Overlay Wall Cabinet Details

SUBMITTAL IDENTIFICATION SHEET

WEBSTER UNIVERSITY ISB
PROJECT NAME

123553-001 REV 2
CONTRACTOR / CM SUBMITTAL NO.

DETAIL OF FRONT TOP CORNER ON WALL CABINETS

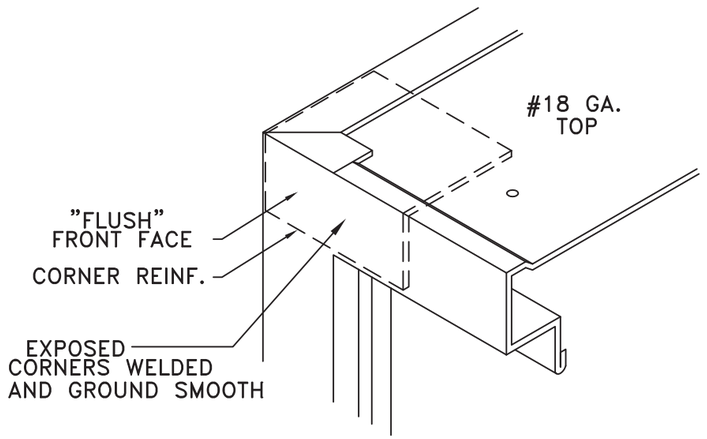
-ALL CABINETS (WOOD, METAL, FLAMMABLE, ACID) TO BE FLUSH OVERLAY.
